Commission of Architectural Review

3. COA-171753-2025	Conceptual Review Meeting Date: 10/28/2025
Applicant/Petitioner	Casey Stone
Project Description	Construct a new multi-family building with a retail ground floor on vacant parcel.
Project Location	
Address: 700 N 21 st Street	
Historic District: Union Hill	
<p>High-Level Details:</p> <p>The applicant proposes a three-story mixed-use building 1,000 sf of ground-floor commercial space and two residential units above. The building fills a narrow, constrained lot and will share a common wall with the adjacent building on N 21st St. The design includes a first-floor storefront wrapping the corner, painted fiber-cement lap siding on the upper floors, cantilevered metal balconies, a steep standing-seam roof, fiberglass pilasters. The applicant is pursuing a reduced side setback.</p>	Staff Recommendation
Staff Contact	Yara Iwaz, Yara.Iwaz@RVA.gov, (804)646-6031
Previous Reviews	<ul style="list-style-type: none"> N/A

Figure 13

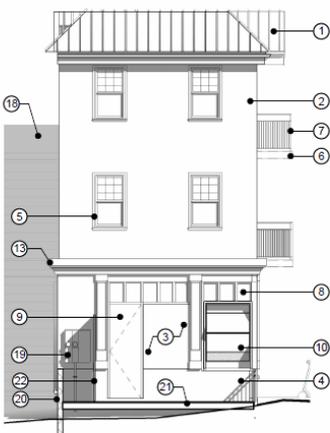
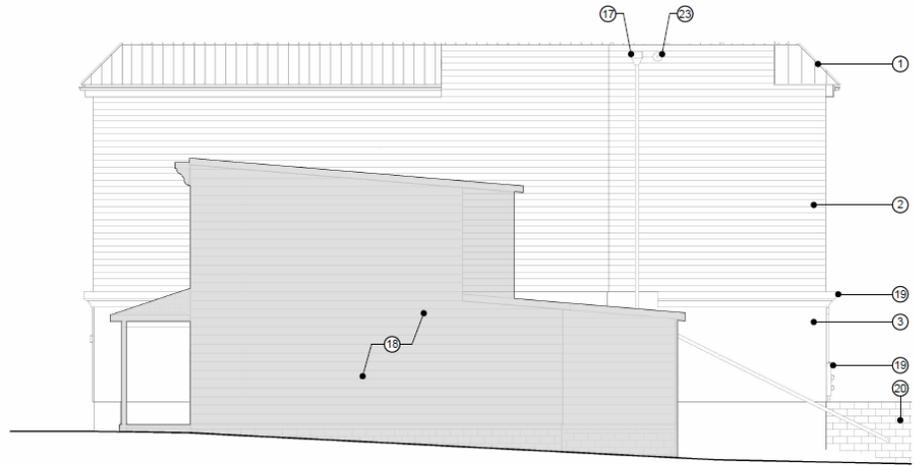
Standards for New Construction: Height, Width, Proportion & Massing, page 47	<p>1. <i>New residential construction should respect the typical height of surrounding residential buildings.</i></p> <p>2. <i>New residential construction should respect the vertical orientation typical of other residential properties in surrounding historic districts. New designs that call for wide massing should look to the project's local district for precedent.</i></p>	<p>Verticality</p> <p>The project features a three-story building, and is notably taller than the adjacent two-story historic buildings. The surrounding context mostly features two-story buildings, but three-story structures are found further down 21st street and in other areas of Union Hill, as well as two-story buildings with significantly raised foundations (See figures below).</p> <p>The design also aims to emphasize verticality (notably through the gabled standing-seam pitched roof form), which results in a scale</p>

<p>that can overpower neighboring historic houses. The height also accentuates the narrow façade, producing a top-heavy appearance inconsistent with the rhythm of the surrounding block. The new building's location on a corner lot further reinforces its prominence and visibility within the historic block.</p> <p><u>Staff recommends studying ways to mitigate the vertical emphasis and reduce the perceived height of the building.</u></p> <p>Some design examples include:</p> <ul style="list-style-type: none"> • Stepping back the second floor on the North 21st Street elevation, to better relate to the smaller neighboring structures, if building setback will remain unchanged • Simplifying roof form to a cornice, as seen in district precedents
<p>Standards For New Construction: Storefront Facades, p.49</p>	<p><i>1. Historically, storefronts were defined by simple piers, large storefront windows, a cornice, a signboard and/or attached signage, and awnings. The new storefront should be compatible with other historic storefronts within the district.</i></p>	<p><i>Commercial Storefront</i></p> <p>The proposed design features fiberglass pilasters that help create articulation on the ground floor and appropriately provides human-scale elements at the storefront level, by breaking the façade into smaller vertical components that reinforce the pedestrian expression of the building and enhance compatibility with the district.</p> <p>However, the pilasters terminate above the parged foundation, which visually appears to weaken the storefront base/ ground connection.</p> <p><u>Staff recommends extending the pilasters down to grade or over the parged foundation, to further enhance the storefront base.</u></p>

<p>Standards For New Construction: Doors and Windows, p.56</p>	<p><i>2. The size, proportion and spacing patterns of door and window openings on free-standing new construction should be compatible with patterns established in the district</i></p>	<p><i>Roof form</i></p> <p>The proposed hipped roof (as seen from the 21st street elevation, on the angled façade in particular) is inconsistent with typical roof forms at corner buildings in this district, which more commonly feature flat or parapeted rooflines and a cornice. The roof's slope accentuates the building's verticality and introduces a more suburban appearance not typical of Union Hill's urban character.</p> <p><u>Staff recommends simplifying the roofline to a flat roof with a cornice treatment, referencing the corner buildings shown in the applicant's contextual imagery.</u> This would help reduce the apparent height and reinforce the building's corner definition.</p>

<p>Standards for New Construction: Height, Width, Proportion & Massing, page 47</p>	<p><i>2. New residential construction should respect the vertical orientation typical of other residential properties in surrounding historic districts. New designs that call for wide massing should look to the project's local district for precedent.</i></p>	<p><i>Secondary Elevation</i></p> <p>The long Cedar Street elevation features two recessed bays with gable-roofed projections and full-height glass balconies. While balconies are seen in the district, their combination with gable forms and transparent glass railings creates a distinctly suburban character inconsistent with the simpler architectural expressions found in Union Hill.</p> <p><u>Staff recommends simplifying balcony treatments, such as eliminating gable projections and opting for a cornice design, to better align with the district's architectural language.</u></p>

<p>Standards For New Construction: Doors and Windows, p.56</p>	<p><i>2. The size, proportion and spacing patterns of door and window openings on free-standing new construction should be compatible with patterns established in the district</i></p>	<p><i>Windows</i></p> <p>The fenestration pattern is vertically aligned and consistent with adjacent buildings, and with the guideline recommendations for corner residential lots (on both the 21st Street and Cedar Street elevations.</p> <p>However, this is new construction, a simpler window could more clearly differentiate old from new.</p> <p><u>Staff recommends simplifying window configurations to 1-over-1 double-hung units, in lieu of the 6-over-6 proposed windows.</u></p>
<p>Standards for New Construction: Materials & Colors, page 47</p>	<p><i>2. Materials used in new residential construction should be visually compatible with original materials used throughout the district.</i></p>	<p><i>Materials</i></p> <p>The proposed materials, including cementitious siding and traditional trim profiles, appropriately reference nearby frame construction and are compatible with materials found in Union Hill.</p> <p><u>Staff recommends approval of proposed materials; colors and finishes to be submitted for final review.</u></p>

Staff Recommendations	<p>Staff finds that the proposed project generally meets the intent the District Guidelines. While some aspects are in alignment with historic district characteristics, others may require more contextual sensitivity. Staff recommends the following:</p> <ul style="list-style-type: none"> Align the primary façade on North 21st Street with the historic setback established by adjacent buildings to maintain the continuous streetwall; confirm final setback through SUP review and show on site plan. Implement ways to mitigate the vertical emphasis and reduce the perceived height of the building. Extend the pilasters down to grade or over the parged foundation, to further enhance the storefront base.

<ul style="list-style-type: none"> • Simplify the roofline to a flat roof with a cornice treatment • Simplify balcony treatments, by eliminating gable projections and opting for a cornice design • Simplify window configurations to 1-over-1 double-hung units • Approve proposed materials; colors and finishes to be submitted for final review.
--	---
